Comments on applications for referral under the COVID-19 Recovery (Fast-track Consenting) Act 2020

Project name	Peachgrove Mixed Use Precinct
General comment – potential benefits	<p>Hamilton City Council (HCC) welcomes the opportunity to comment on the referral application by Hamilton Campground Limited (HCL) to an expert consenting panel for fast-track consenting under the Covid-19 Recovery (Fast-track consenting) Act 2020 (FTCA).</p> <p>HCC has experienced strong growth over the past 10 years. The Draft Urban Growth Strategy identified over the next 50 years, Hamilton will accommodate a population of 310,000 people. With the increase of approximately 2600 people per year, this requires between 870 to 1000 new houses to be constructed per year. The proposal seeks to develop up to 170 residential units comprised of a mix of housing typologies, including apartments and terraced homes, providing a range of accommodation options from 2-beds, 3-beds, as well as 4-beds. This proposal alone would achieve nearly 20% of the yearly housing target for Hamilton and create a positive impact towards providing quality housing stock in an area that is within close proximity to the CBD and surrou

Figure 3: The applicant's proposed Master Plan, with the proposed retail, F&B, Gym and Retail highlighted in yellow.

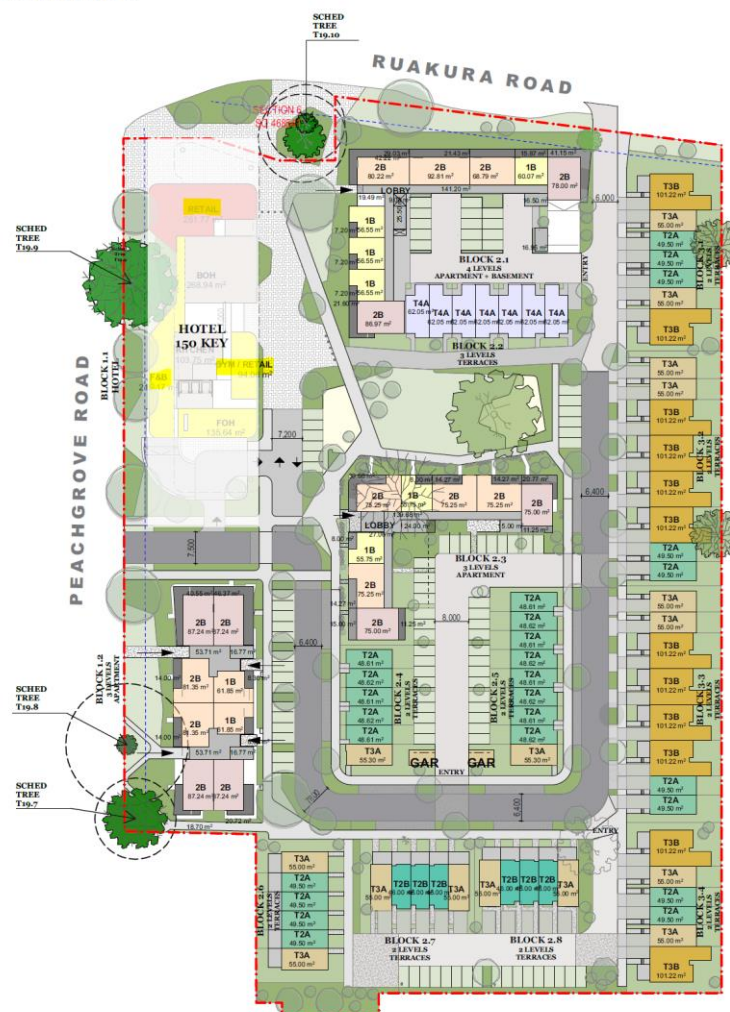
Further to the applicant's assessment, I note that the associated hotel activities may trigger a non-complying activity if any rooms within the complex are used as a seminar room/conference facility. In addition, a restaurant (what the applicant has identified as 245.17m² for Food and Beverage) also triggers a non-complying activity. Gym and retail are not activities provided for within the General Residential zone, hence pursuant to 1.1.8 of the ODP, a **Non-Complying Activity** is triggered.

I also want to acknowledge the main development controls/general standards within the General Residential Zone within the operative plan. Specifically, I notice there's a significant diversion of what is anticipated by the ODP in terms of building bulk (height), and that part of the proposal would result significant infringements in terms of the anticipated building envelope.

Pursuant to 1.1.8.2 of ODP, infringement of any standards will be assessed as a Restricted Discretionary Activity unless specifically stated otherwise in the relevant Activity Status Table. Although, I note the proposed hotel complex will well infringe the 10m anticipated height within the General Residential Zone.

Figure 1: Catchment study of how far the subject site can reach by foot and bike in both a 20 min and 10min timeframe.

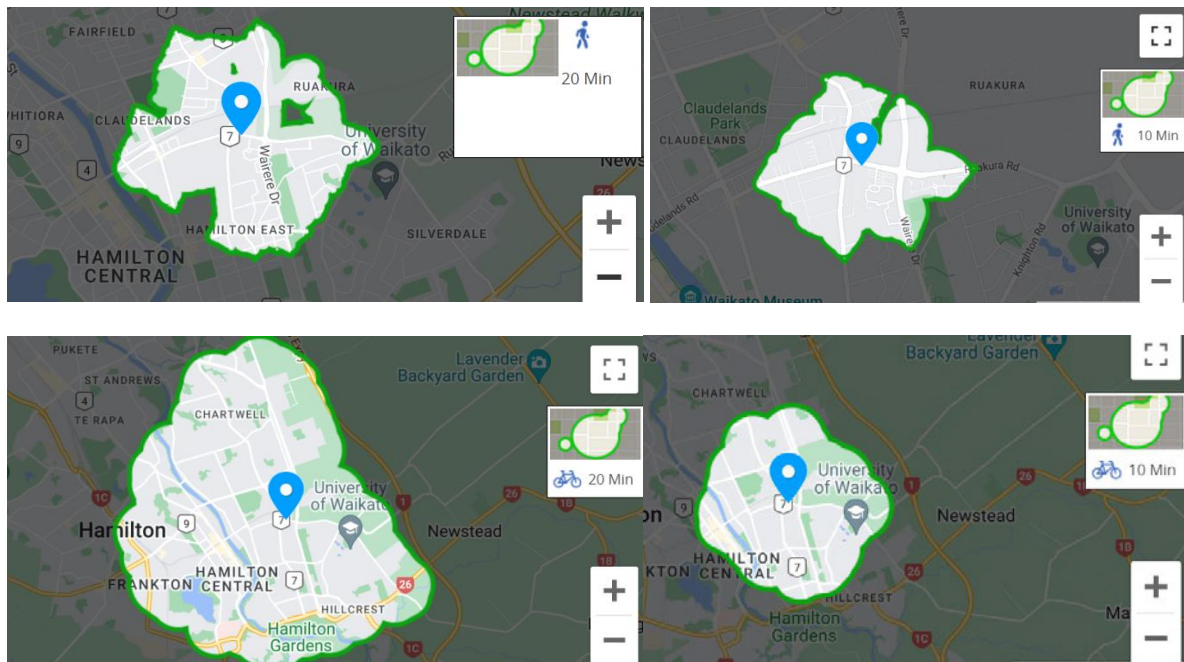
Context: The site is part of an emerging area where more density is likely to occur in the near future. A brief diagram of the walkable catchment of 20 mins and 10 mins are provided below, which indicate the subject site is just outside of a 20-min actual distance walkable catchment to the CBD. Nonetheless, the development site can reach the CBD within a 10 min bike ride, and a 20 min bike ride serves nearly all the key facilities within Hamilton. It is therefore reasonable to plan for how future hotel users will be accessing the site. The integration of bike facilities is really important to encourage sustainable transport modes are used to access the CBD, especially the site is bonded by the cycle network.

Having consider the strategic location of the site, and the relatively flat topography, I consider the mixed-use nature is appropriate for its context, given that this 4way intersection gateway can absorb greater built form scale and bulk, and it would not be considered out of the ordinary as the opposite block already consists of a number of non-residential/community/commercial activity. However, the treatment of the northwestern corner requires further design consideration as the hotel use would create a more defined gateway into both Ruakura Road and Peachgrove Road. Specifically, as the building stands, this key corner did not consider a 'wrap around' corner which provides improved legibility to the area. The plans on page 8 and page 9 also shows discrepancy for the proposed built form for Block 1.1.
